PCN20231213001.1
Qualification of additional Assembly sites for select HSOIC devices
Change Notification / Sample Request

PCN Number:	20231213001.1	PCN Date:	December 21, 2023
Title:	Qualification of additional Assembly sites for select HSOIC devices		
Customer Contact:	Change Management Team	Dept:	Quality Services
Proposed 1st Ship Date:	Mar 20, 2024	Sample requests accepted until:	Jan 21, 2024*

Sample product shipping label (not actual product label)

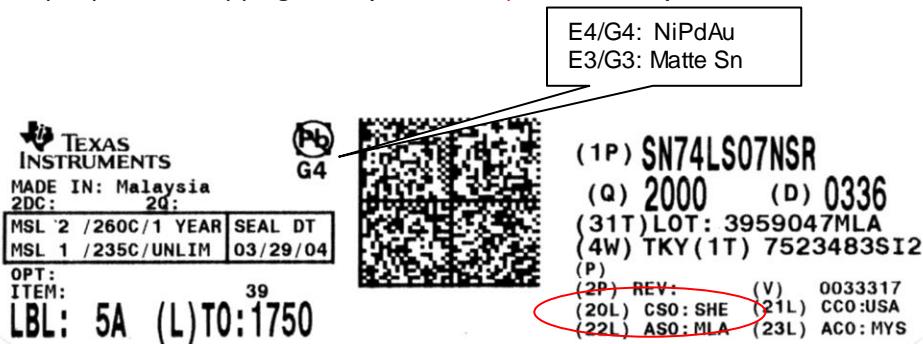
Changes to product identification resulting from this PCN:

Assembly Sites		
HNA	Assembly Site Origin (22L)	ASO: HNT
AP1	Assembly Site Origin (22L)	ASO: AKR
ASESH	Assembly Site Origin (22L)	ASO: ASH
FMX	Assembly Site Origin (22L)	ASO: MEX
TITL	Assembly Site Origin (22L)	ASO: TAI
